Friends of Squibnocket, LLC
PO Box 267
Chilmark, MA 02535

October 24, 2014

MEMORANDUM

DATE: October 28, 2014
TO: Town Committee on Squibnocket
FROM: Stanley M. Humphries and Mark L. Manganello
RE: Response to the Lasser Letter and Haley & Aldrich Memorandum – Dated October 13, 2014

Figure 1: Dune cross-sectional area required above the 100-year still water flood level (SWFL) to protect against various return period storm events.

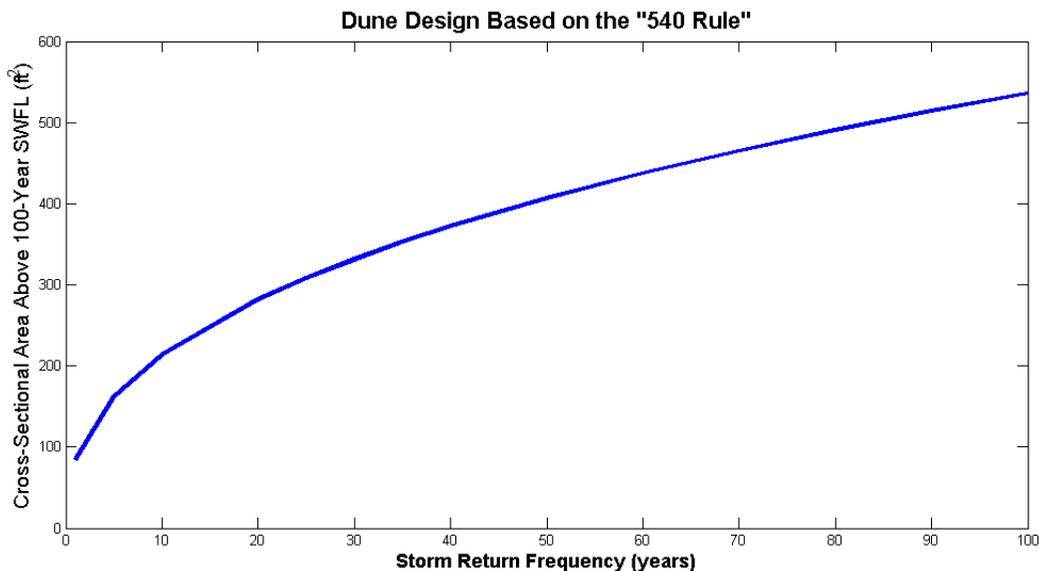
Design of coastal dunes for shore protection requires both sufficient elevation and volume to resist the impacts of coastal storms. FEMA developed guidelines regarding the required cross-sectional area of a dune needed to survive a 100-year storm and determined that approximately 540 ft² is required based upon erosion data related to 46 historical storm events. Figure 1 illustrates the cross-sectional area of dune required above the 100-year still water elevation necessary to withstand various return-period events. The initial dune design developed for Squibnocket Beach consists of approximately 490 ft² above the 100-year storm level and 555 ft² above the 50-year storm level. Based on Figure 1, the initial dune volume can withstand a storm less than ~75-year return frequency event.

It should be noted that the design calculations are based upon the initial volume and height of beach compatible material placed. As ongoing erosion reduces the volume of the dune, its ability to withstand storm events is reduced (as shown in Figure 1). It is anticipated that dune repair/replenishment will be required approximately every 10 years to (a) allow the shoreline to migrate landward naturally by periodically 'repositioning' the dune and roadway, and (b) replenishing the eroded dune volume to ensure it provides the level of protection desired.
